RE: JMC Project 22090  
BaySpace Armonk  
100 Business Park Drive  
Town of North Castle, NY

**Response to Town Comments Resubmission**

Town of North Castle Planning Department Memorandum, dated June 19, 2023

**OVERALL SITE LANDSCAPING & WETLAND MITIGATION PLAN**  
 BAYSPACE ARMONK  
 100 BUSINESS PARK DRIVE  
 TOWN OF NORTH CASTLE, NEW YORK

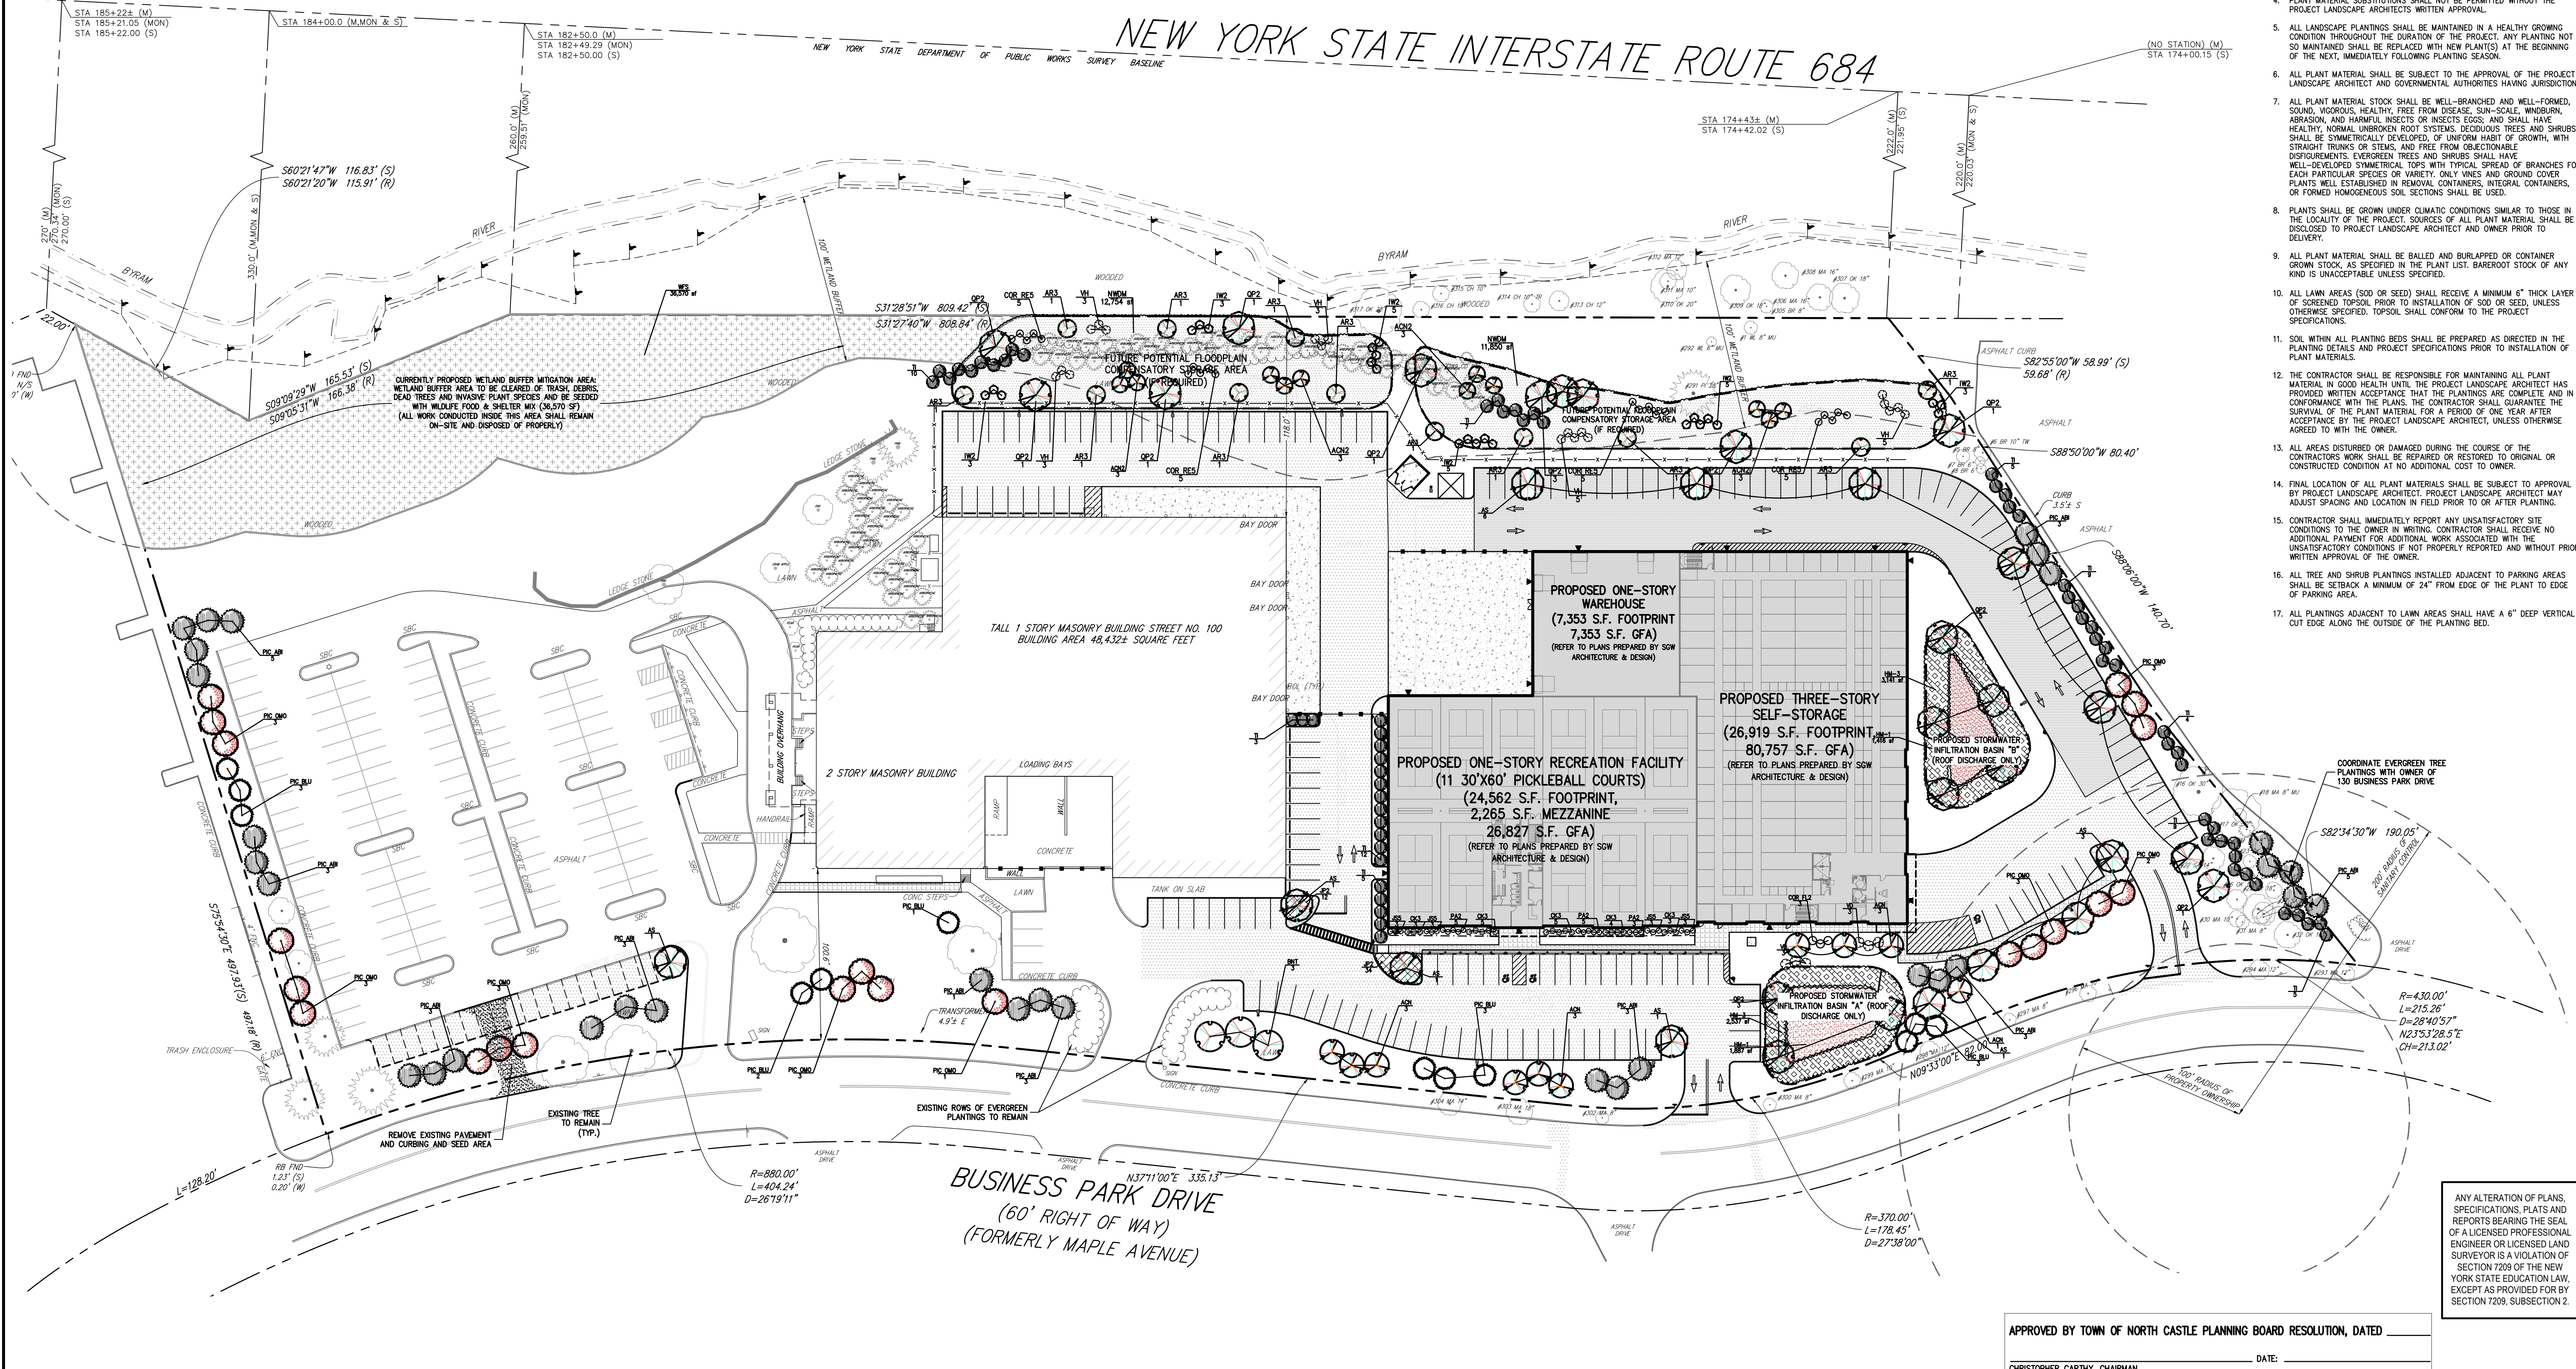
*The Byram River is located at the rear of the property. The site plan should be revised to depict the proposed amount of Town-regulated wetland buffer disturbance. A mitigation plan that is twice the size of the proposed amount of disturbance is required to be submitted.*

The proposed wetland buffer disturbance area is 5,615 SF/0.128 AC, and the proposed wetland buffer mitigation planting area is 36,570 SF/0.839 AC, these areas are depicted on Drawings C-500A and C-500.
